- 2. Homer One Swan Cove Addn. 2022 Replat
KPB File 2022-165**

HOMER ONE SWAN COVE ADDN. 2022 REPLAT

STAFF REPORT

Staff Report 22-63

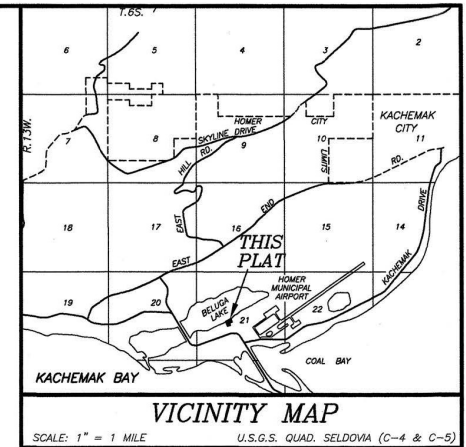
- “1. Include a plat note stating property is subject to the City of Homer regulations check with City of Homer Planning Department prior to any development activity.
2. Update plat note #3 to map number 02122C2020E effective 10/20/2016, revision 17-10-0041P-020107 effective 3/31/2017. Check with Kenai Peninsula Borough regarding panel number/format.
3. The City of Homer does not object to an exception to the roadway width of Lakeshore Drive.”

Staff recommendation: Place the following notes on the plat.

- Add a note for any exception granted.

Staff recommendation: Correct typo at the beginning of Certificate of Ownership. Comply with 20.60.190.

Items one and two have been addressed and item 3 shows their support for the exception request.

HOMER ONE SWAN COVE ADDN. 2022 REPLAT

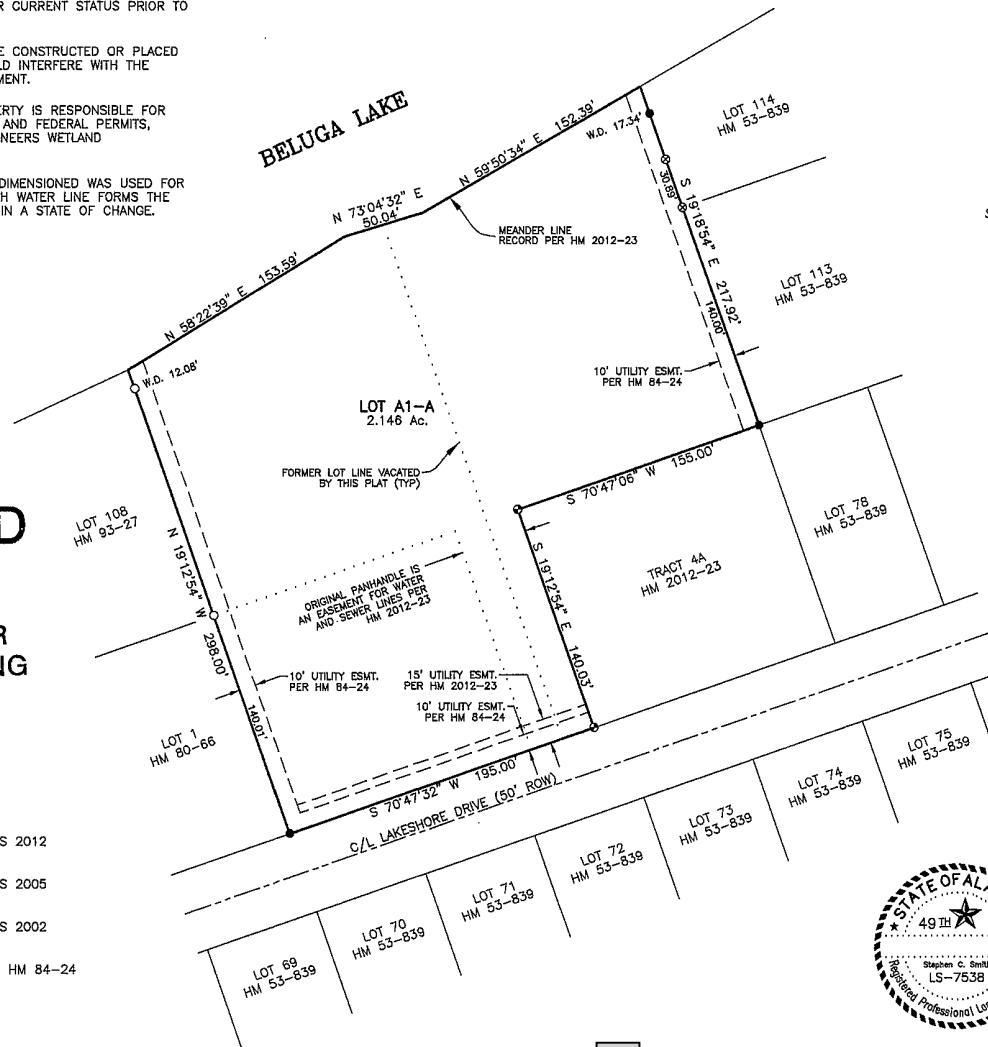
1. Include a plat note stating "Property is subject to City of Homer regulations. Check with Homer Planning prior to any development activity."
2. Update plat note #3 to map number 02122C2020E effective 10/20/2016, *Revision 17-10-0041P-020107 effective 03/31/2017....* Check with Kenai Peninsula Borough regarding panel number/format.
3. The City of Homer does not object to an exception to the roadway wide of Lakeshore Drive.
